# PCN - 21 110

<b>Product Name:</b>	Dsub – HPL: 569	
	Delta-D straight version connectors	
<b>Product Manager:</b>	Vicy Pulayath	
<b>Subject:</b>	Notification of Planned Change	
<b>Distribution:</b>	Affected customers	
<b>Type of Change:</b>	Documentation Change	
<b>Change Description:</b>	Harpoon length corrected as 4.3mm max.	
<b>Reason for Change:</b>	To correct the error shown in the drawing compared to actual Harpoon length	
<b>Affected Parts:</b>	See Affected Parts.xls file	
<b>Effective Date of Change:</b>	01 November ,2021	
<b>Last Time Buy Date:</b>		
<b>Earliest Disty Return Date:</b>		
<b>Last Time Shipment Date</b>		
<b>Datasheet Attached?</b>	NA	
<b>Qual/Test Data Attached?</b>	NA	
<b>Samples Availability Date:</b>	20 September ,2021	
<b>Available Alternatives?</b>		
<b>Questions?</b>	<i>Contact your local AICC Representative, or Product Manager</i>	
	<i>Vicy Pulayath / Product Manager</i>	
	<i>Vicy.Pulayath@fci.com</i>

PRODUCTS: Delta-D Straight version Harpoon length change

Site CCB No./Global PCN No.- COK-042-21

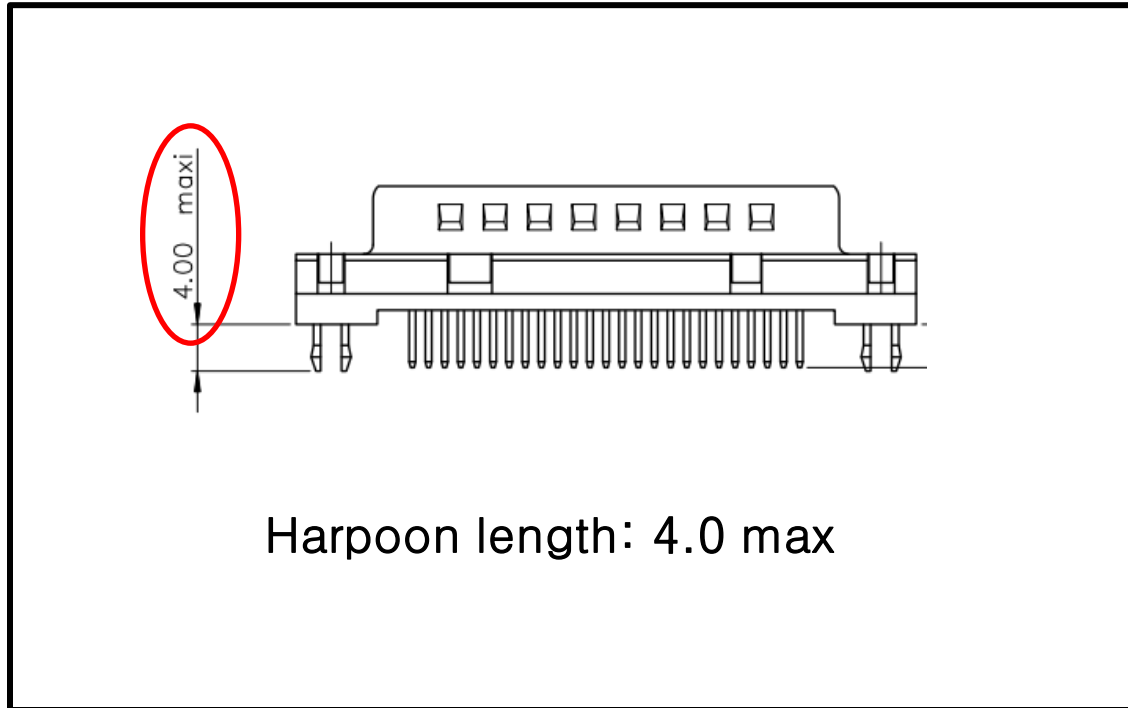
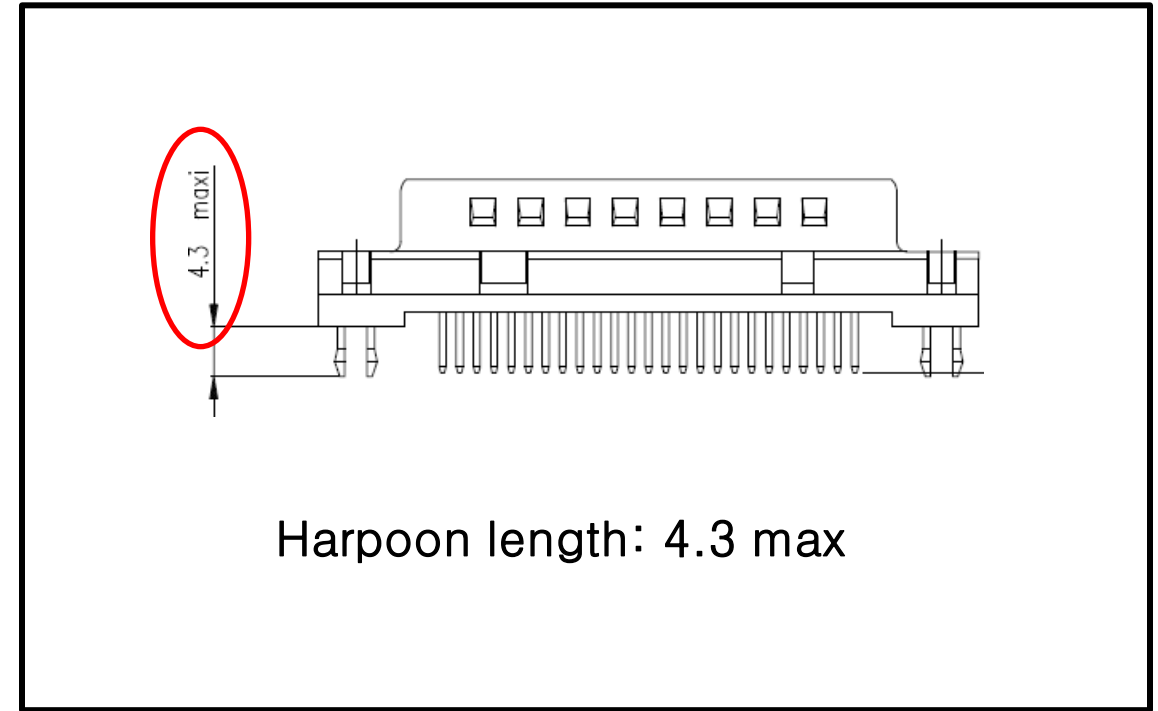
- Drawing change for Delta D straight version with harpoon
- Change is done to match drawing with actual dimension
